CITY OF PORTERVILLE
CALIFORNIA
ANIMAL SHELTER PROJECT
PROJECT NO: 89-9015-88
BID NO: 21/22-CP1918 (Rebid)

BEGINNING OF ADDENDUM No. 2

Date: August 5, 2022

E2.0	POWER PLAN LEVEL 01
------	---------------------

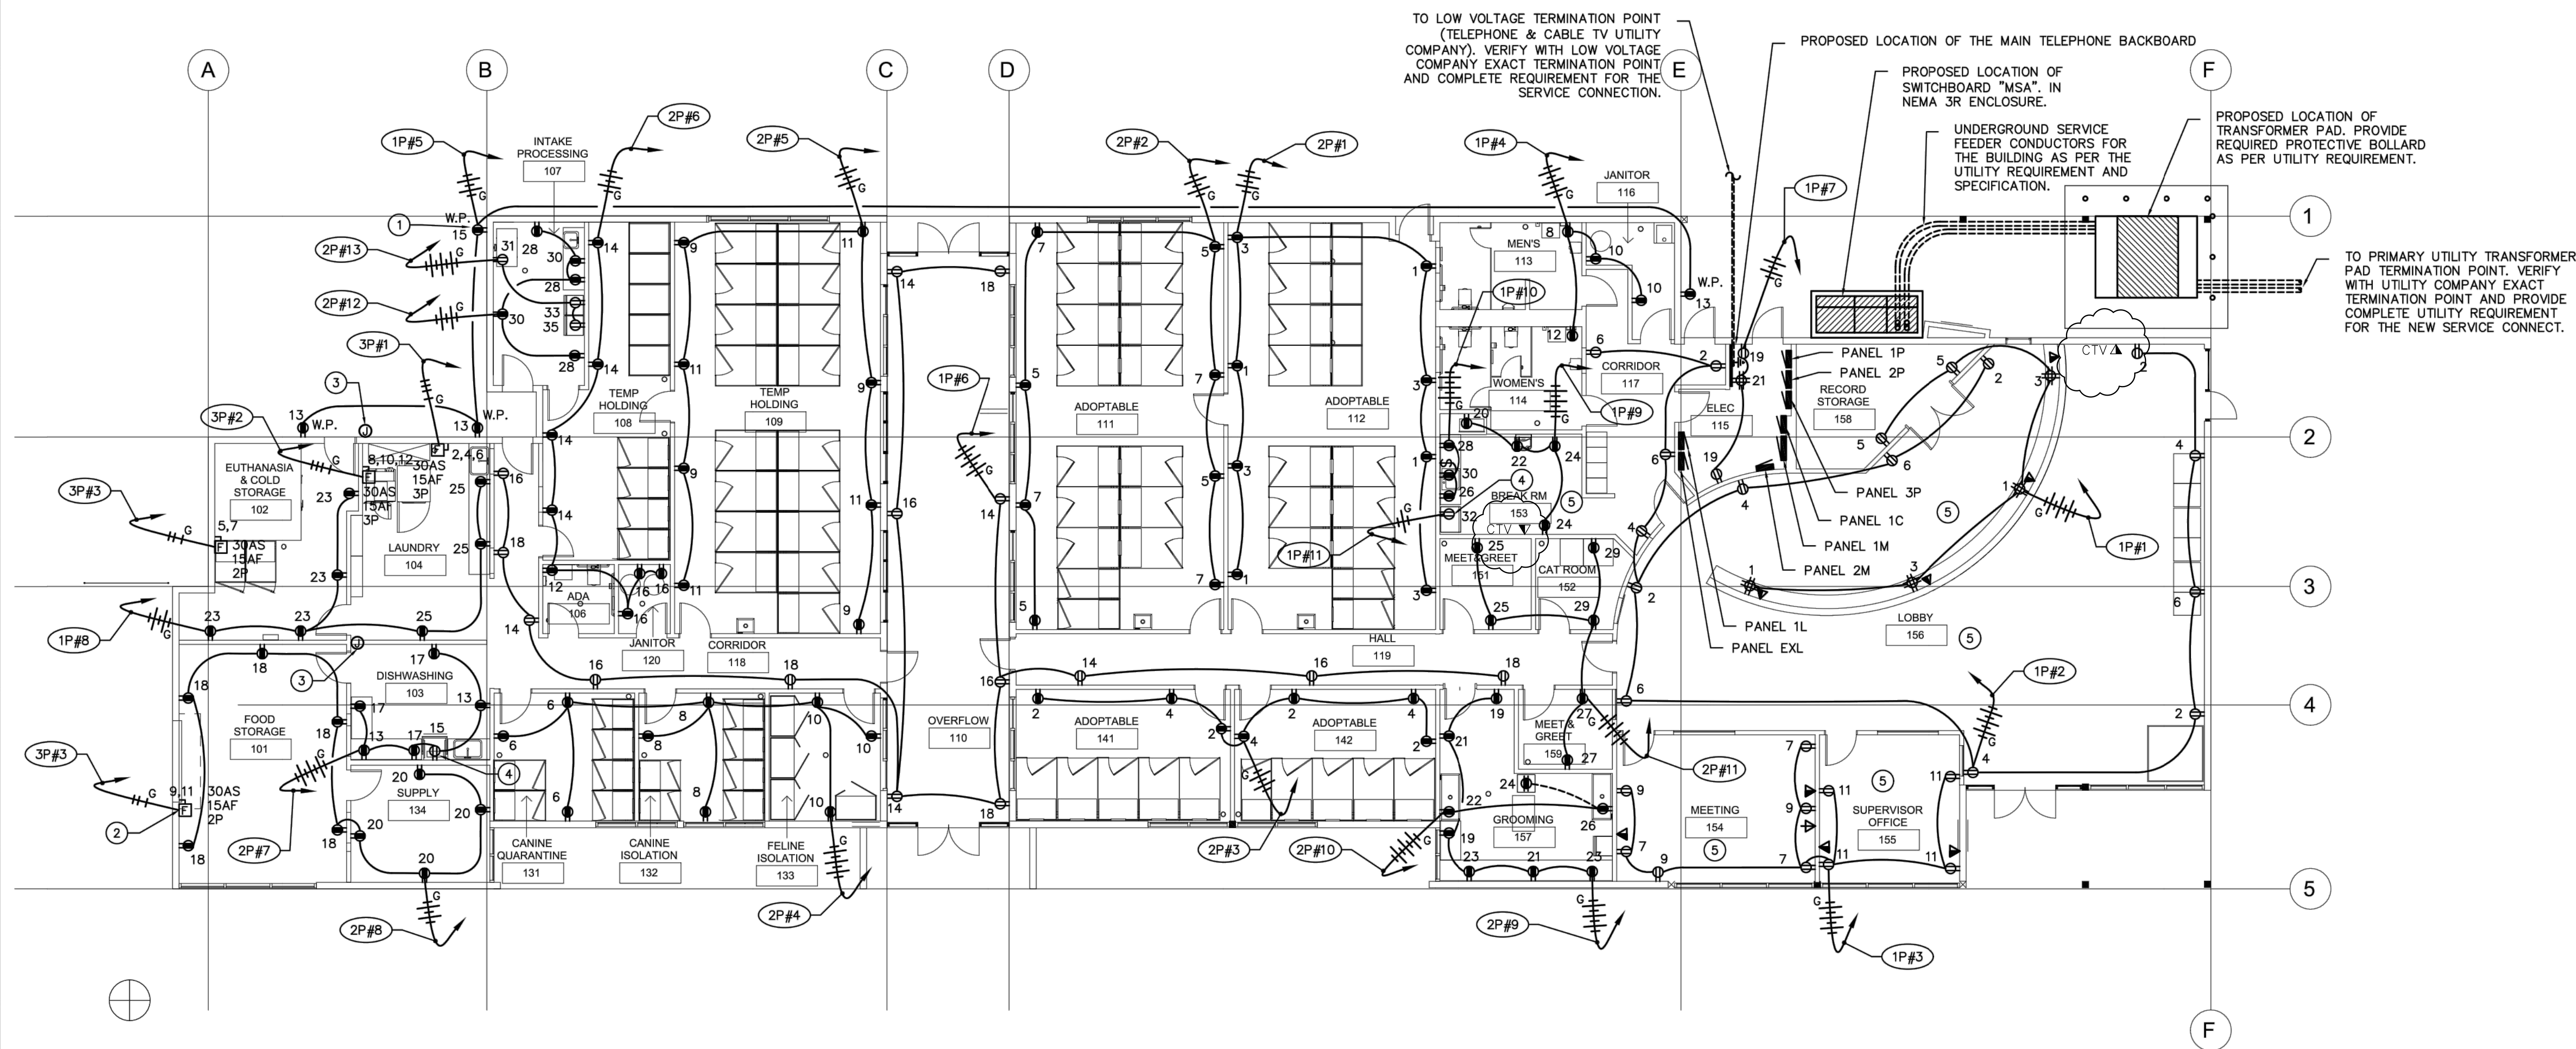
Sheet E2.0 has been updated and is attached and shall replace the existing Sheet E2.0 in the plans. The update has been bubbled and includes additional data outlets (some are already on the plans) as well as the location of the cable tv outlets. Telephone/data port symbol is found in the legend on sheet E1.0 of the plans. All data port outlets shall have CAT6 cabling ran to them.
